April 3, 2024

IDEA Public Schools Upper RGV Mechanical Upgrades CSP#23-URMU-0424

ADDENDUM NO. 2

ME3.4

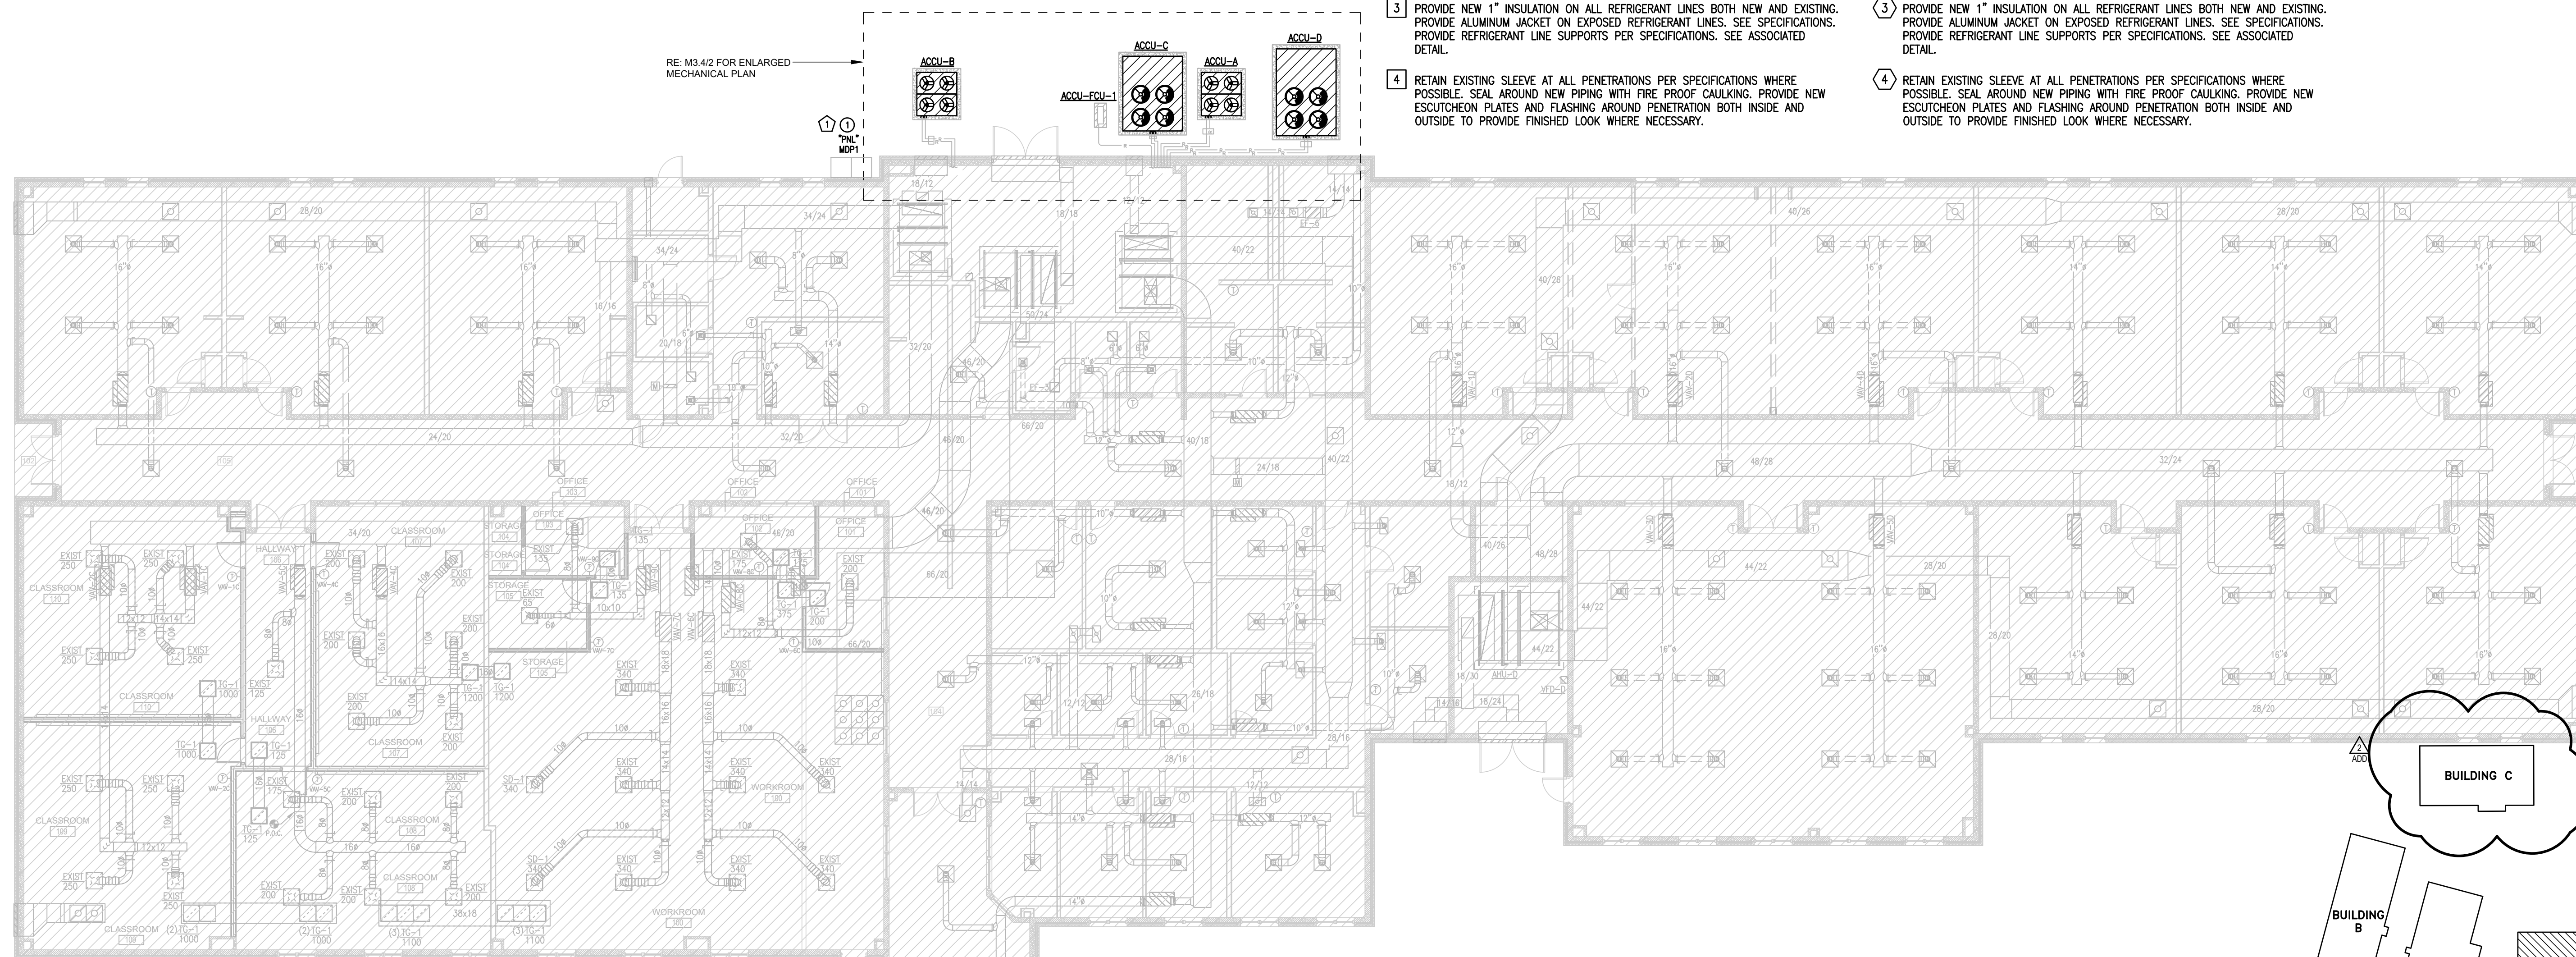
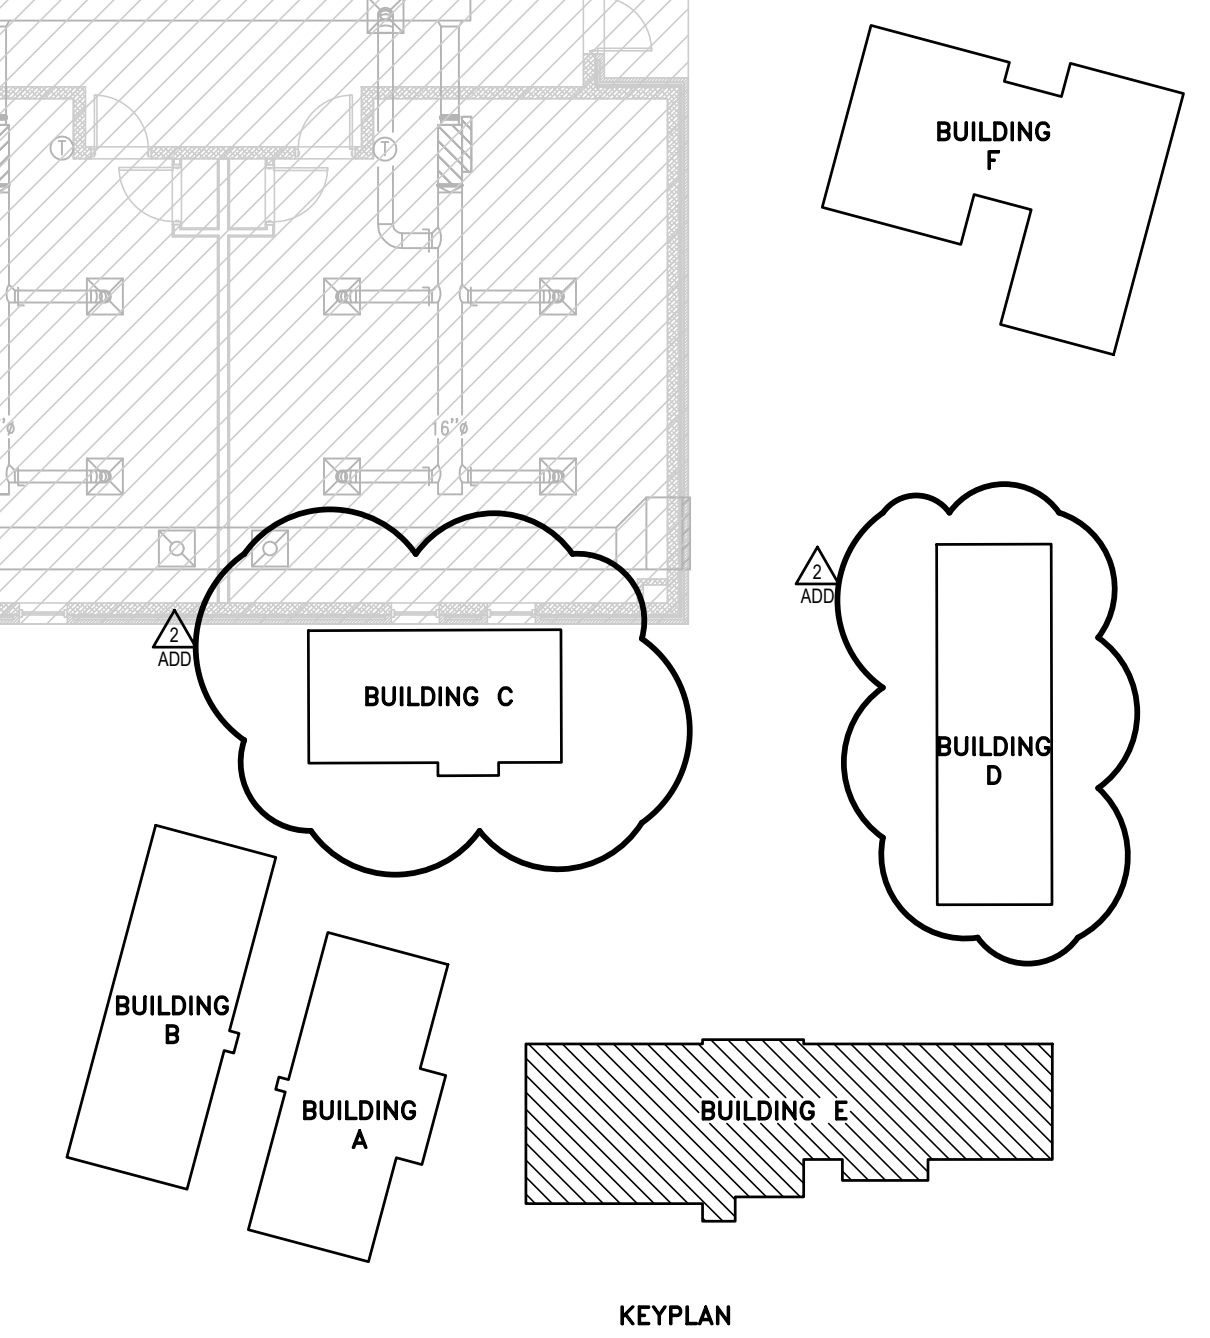
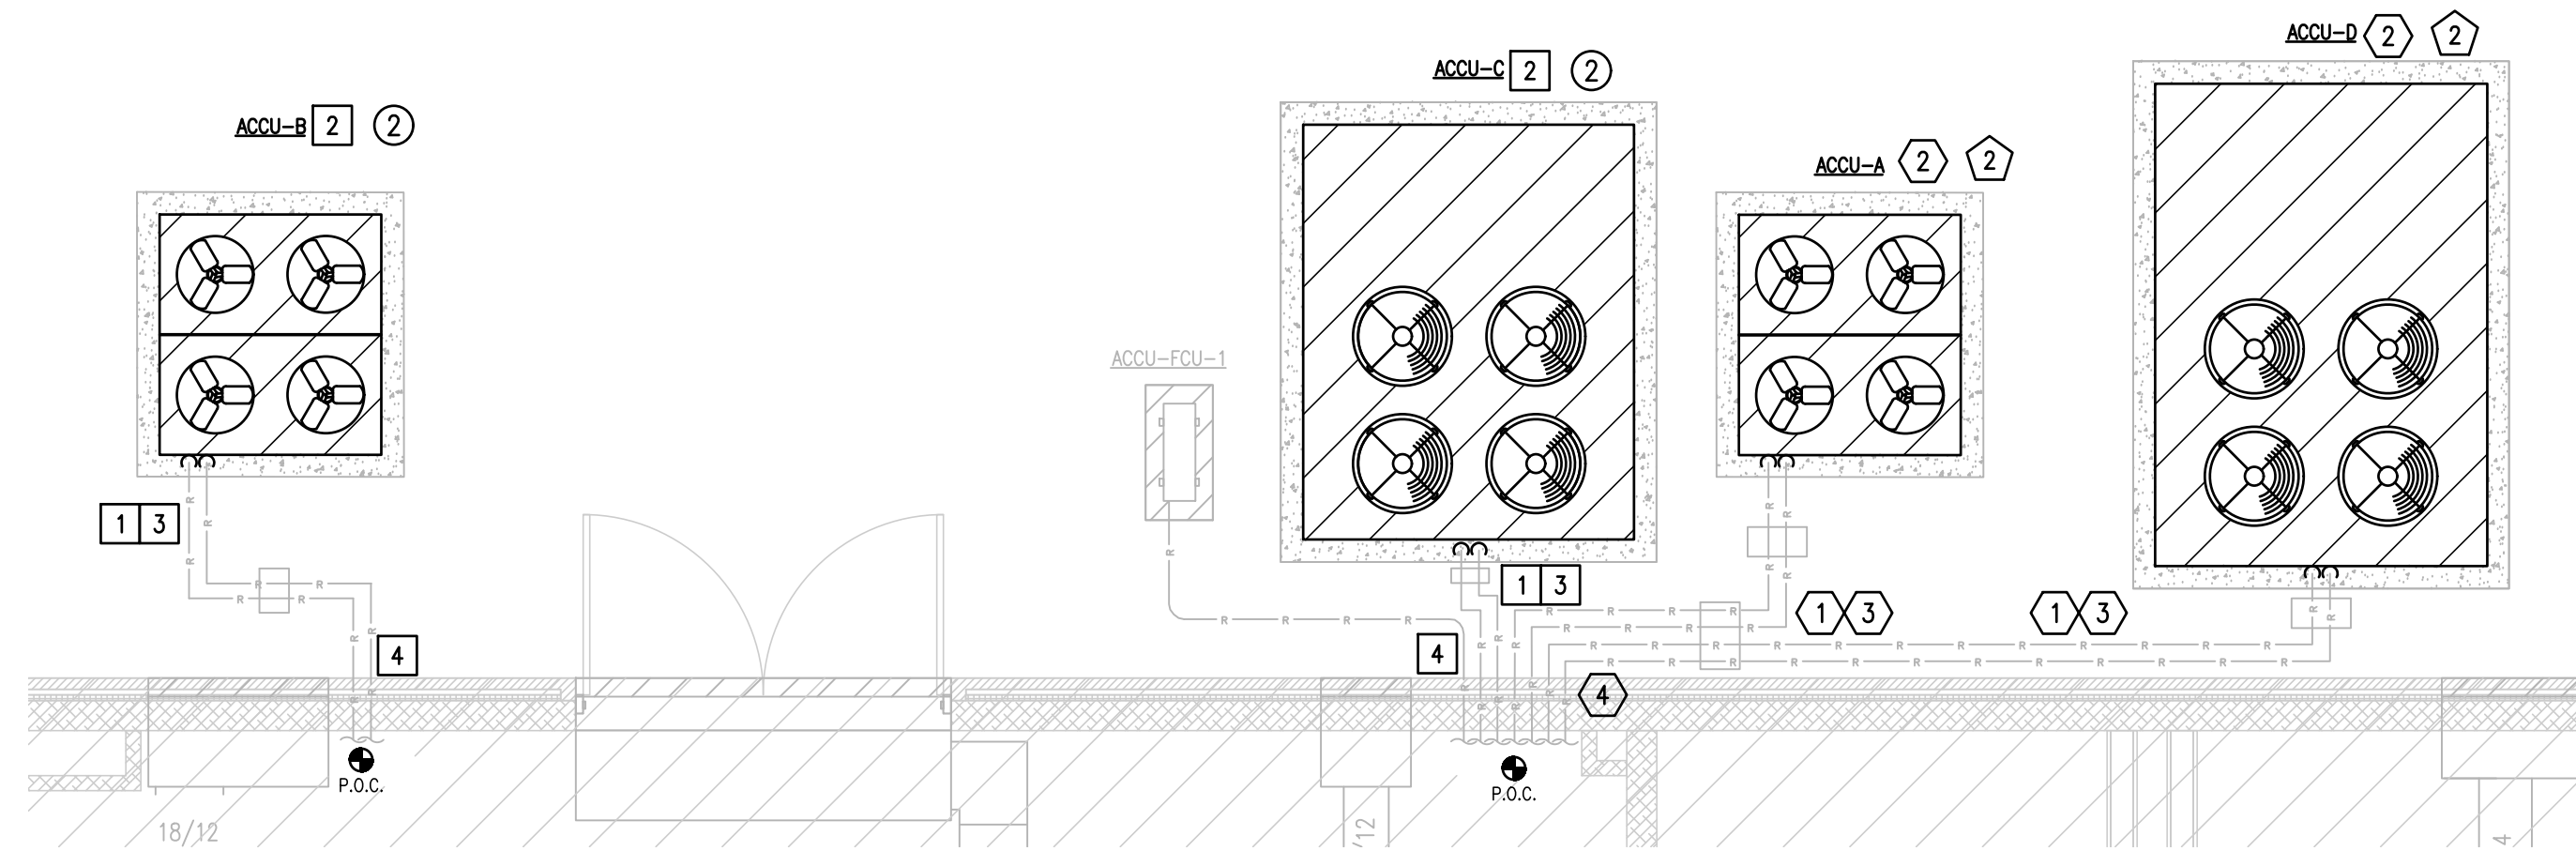
6. Sheet ME-3.4 – See attached.
 - a) Added Base Bid identification to schedules.
 - b) Updated keyplan.
7. Sheet ME-4.1 – See attached.
 - a) Added Base Bid identification to schedules.
